ATTACHMENT 1

PROPOSED TECHNICAL SPECIFICATION CHANGES FOR NORTH ANNA UNIT 2

ATTACHMENT 2

DISCUSSION OF PROPOSED CHANGES

Figure 3.2-1 AXIAL FLUX DIFFERENCE LIMITS AS A FUNCTION OF RATED THERMAL POWER

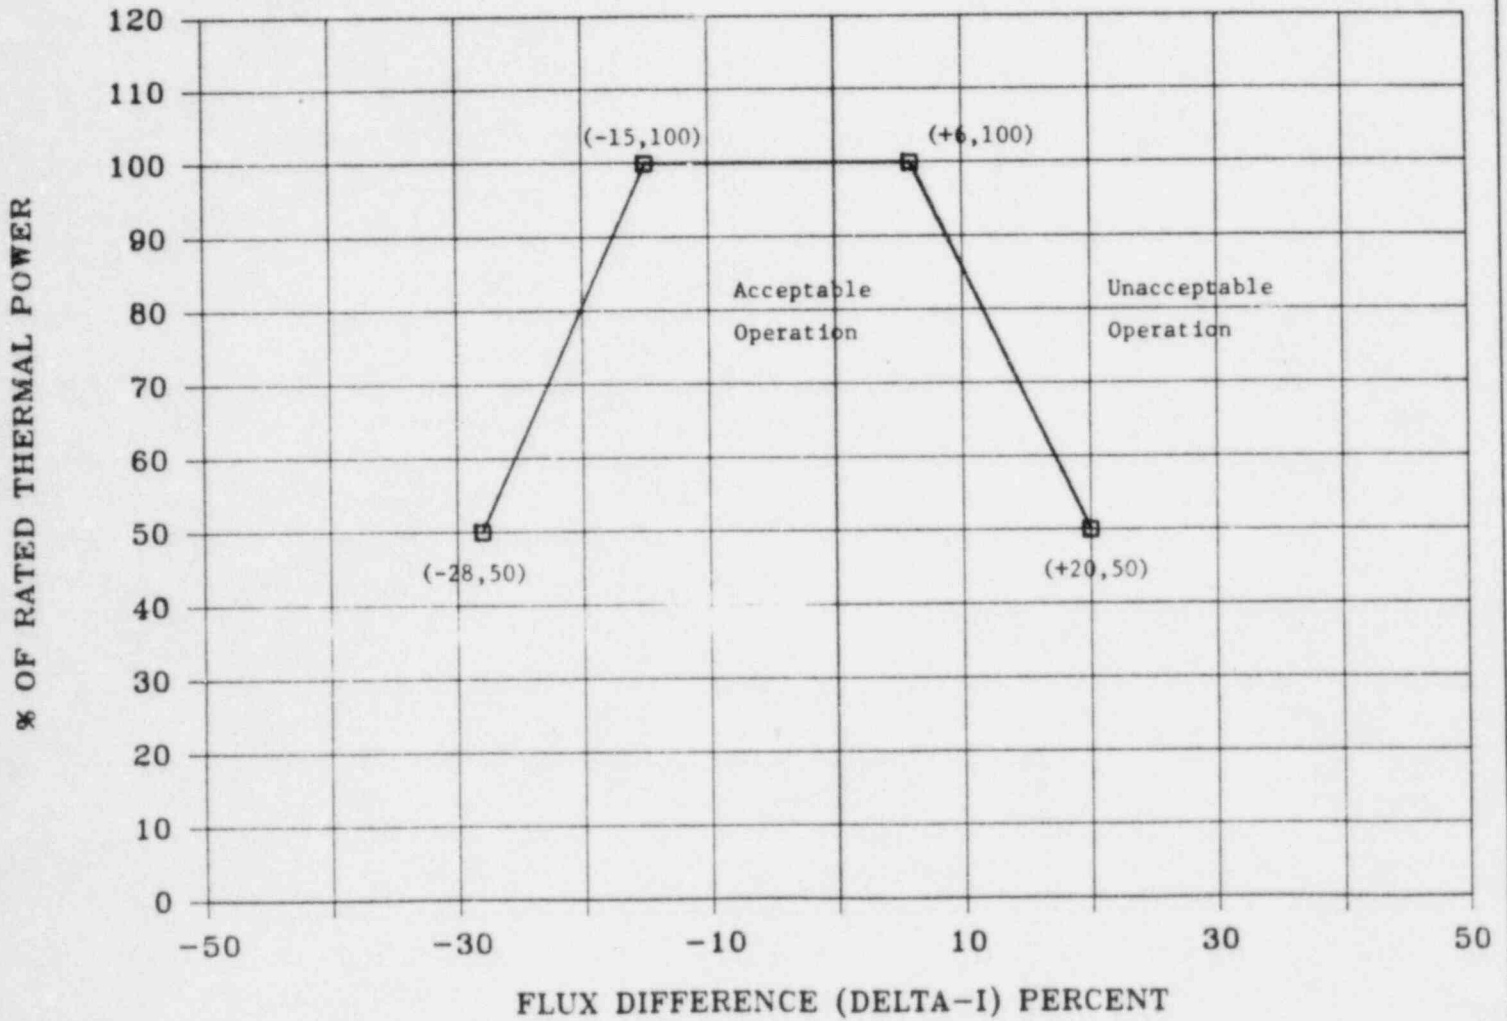
3.2.1 The indicated AXIAL FLUX DIFFERENCE (AFD) shall be maintained within the allowed operational space defined by Figure 3.2-1.

- a. With the indicated AXIAL FLUX DIFFERENCE outside of the Figure 3.2-1 limits,
 - 1.) Either restore the indicated AFD to within the Figure 3.2-1 limits within 15 minutes, or
 - 2.) Reduce THERMAL POWER to less than 50 % of RATED THERMAL POWER within 30 minutes and reduce the Power Range Neutron Flux - High Trip setpoints to less than or equal to 55 percent of RATED THERMAL POWER within the next 4 hours.
- b. THERMAL POWER shall not be increased above 50% of RATED THERMAL POWER unless the indicated AFD is within the Figure 3.2-1 limits.

4.2.1.2 The indicated AFD shall be considered outside of its limit when at least 2 OPERABLE excore channels are indicating the AFD to be outside of the limit shown in Figure 3.2-1.

All references to the indicated AFD target and operating band have been deleted, replacing them with AFD limits consistent with the RPDC methodology of Reference 2. In the Action Statement associated with the Limiting Condition for Operation (LCO), the requirement to restore the indicated AFD to within the limits within 15 minutes has been retained. If this requirement is not met, power must be reduced to less than 50% of rated within 30 minutes. As discussed in Reference 2, maintaining the AFD within the prescribed limits will ensure that: 1) the maximum expected $FQ(Z)$ will not exceed the limit specified in Section 3.2.2; 2) the axial power

distribution in the core will not fall outside the range of preconditions used to ensure that the overtemperature delta-T and overpower delta-T functions provide adequate core protection ; and 3) the UFSAR analysis of the Complete Loss of Flow event remains limiting. The lower limit of 50% power on imposing AFD limits is consistent with the current Technical Specifications.
